Vida + H14 + H14.4 + New Training Campus
Entrance Widening Proposal:

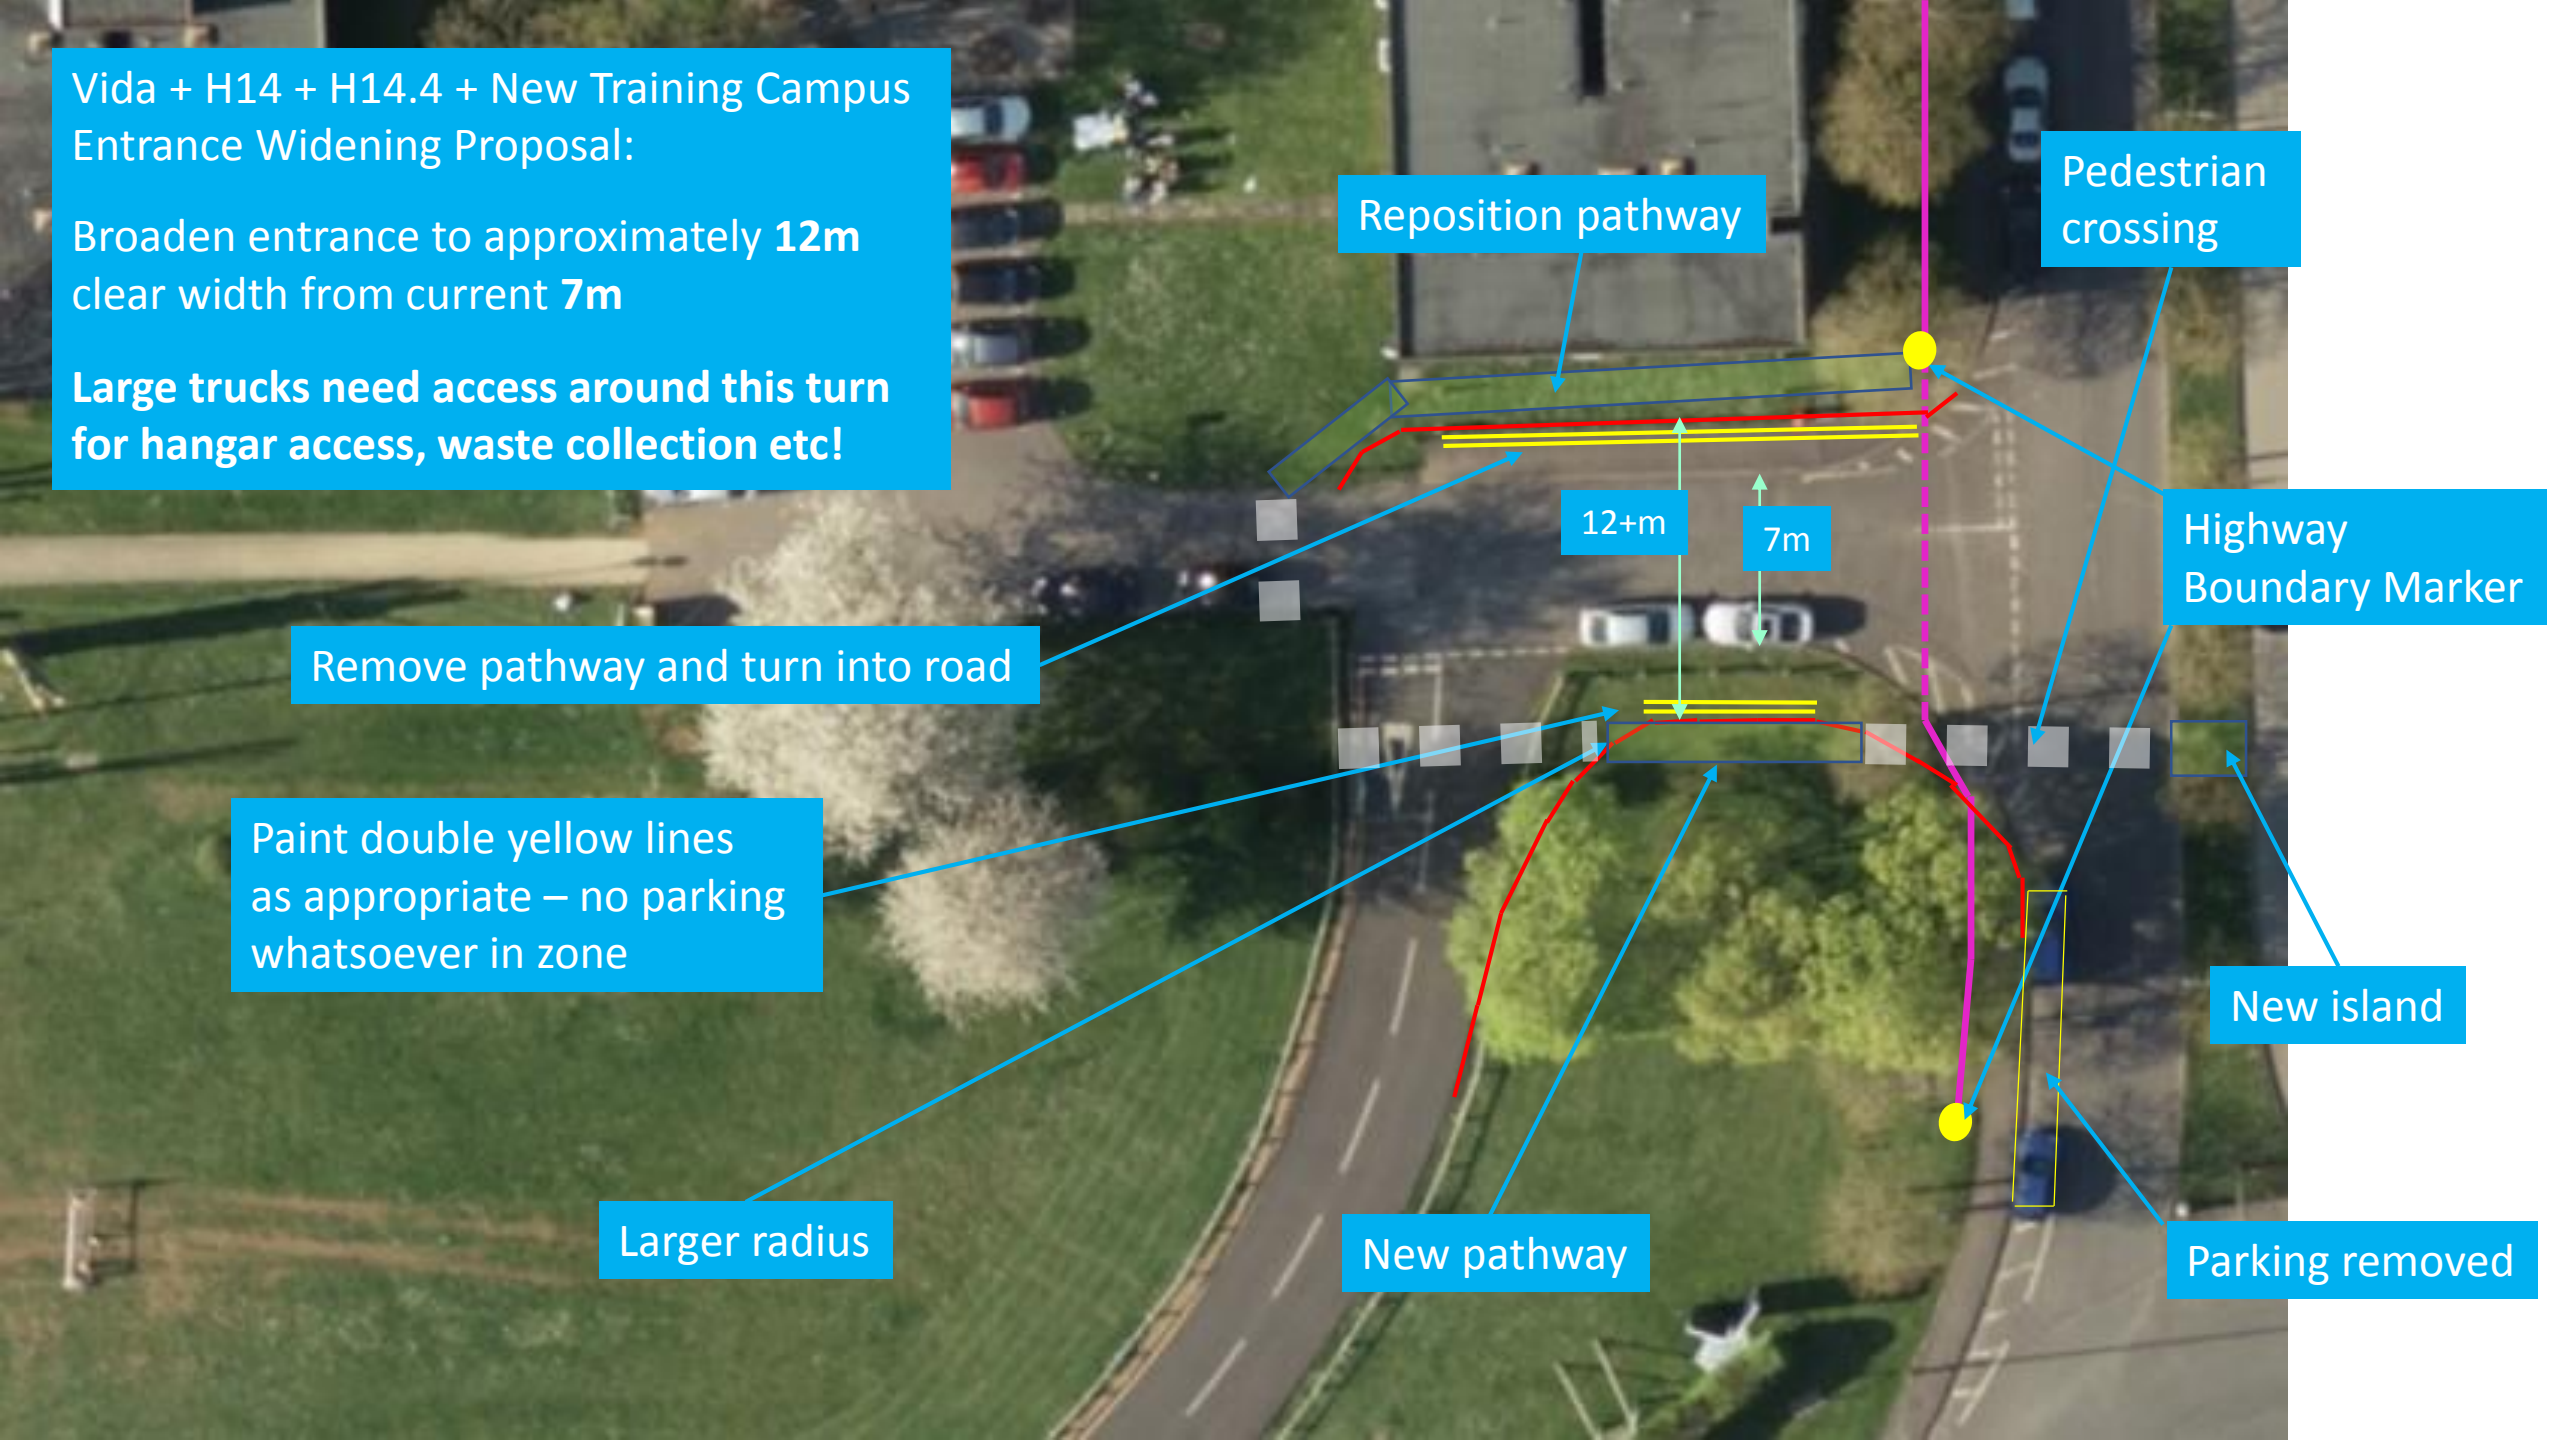
Broaden entrance to approximately **12m**
clear width from current **7m**

**Large trucks need access around this turn
for hangar access, waste collection etc!**

Remove pathway and turn into road

Paint double yellow lines
as appropriate – no parking
whatsoever in zone

Larger radius

New pathway

Reposition pathway

12+m

7m

Pedestrian
crossing

New island

Parking removed

Revised pedestrian infrastructure

New footpath

Parking spaces to be removed
